Access Compliance Report

Public Rights-of-Way

Intersection ID: 24477	Main Street: CHRISTIAN_TYLER_CT	Cross Street: WRIGHT'S_FERRY_RD	Location: W
ADA ID: A5EAF2066838	Ramp Type: BlendTrans2	Initial Pass/Fail: Pass	Overall Compliance: No
			Severity Score: 10

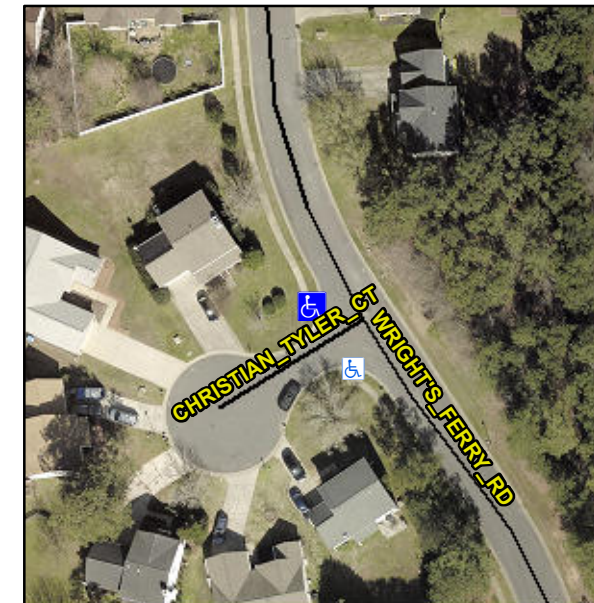
Not Found, R305, R304.5.3

Compliance	Description	Data	Compliance	Description	Data
N/A	Ramp Length (in)	99.5	Yes	BlendTrans Slope (%)	4.2
Yes	Ramp Width (in)	53.5	Yes	BlendTrans XSlope (%)	2.0
N/A	Flare Type LT	None	N/A	Flare Type RT	None
N/A	Flare Slope LT (%)	N/A	N/A	Flare Slope RT (%)	N/A
N/A	Flare Traversable LT?	N/A	N/A	Flare Traversable RT?	N/A
N/A	Landing Length (in)	N/A	No	DWS Provided?	No
N/A	Landing Width (in)	N/A	N/A	DWS Contrast?	No
N/A	Landing Slope (%)	N/A	N/A	DWS Length (in)	N/A
N/A	Landing X Slope (%)	N/A	N/A	DWS Full Width?	No
N/A	Landing Curb? (Y/N)	No	N/A	DWS Offset (in)	N/A
N/A	Shared Landing?	No			
Yes	Gutter Ponding?	No	Yes	Gutter Slope (%)	3.6
Yes	Gutter Lip Ht (in)	0.0	No	Gutter X Slope (%)	2.1
N/A	Painted X Walk1?	No	N/A	Painted X Walk2?	No
	X Walk 1 Direction	To SE		X Walk 2 Direction	To NE
	X Walk 1 Width (in)	N/A		X Walk 2 Width (in)	N/A
	X Walk 1 Slope (%)	0.3		X Walk 2 Slope (%)	3.4
	X Walk 1 X Slope (%)	1.5		X Walk 2 X Slope (%)	1.4

N/A	Ramp inside XWalk1?	N/A	N/A	Ramp inside XWalk2?	N/A
	Road Slope (%)	1.8		Clear Space?	Yes
	Road X Slope (%)	2.8	N/A	Clear Space to XWalk (in)	N/A
Yes	Any Obstructions?	No	Yes	Storm Grate/Utility Hazard?	No
	Obstruction Type			Storm Grate/Utility Type	
		N/A			N/A
			Yes	Surface Condition? (G/P)	Good
			No	Curb Slope (%)	12.7

Remove & Replace Curb Ramp With Two New Directional Ramps or Equivalent. Remove & Replace Gutter.
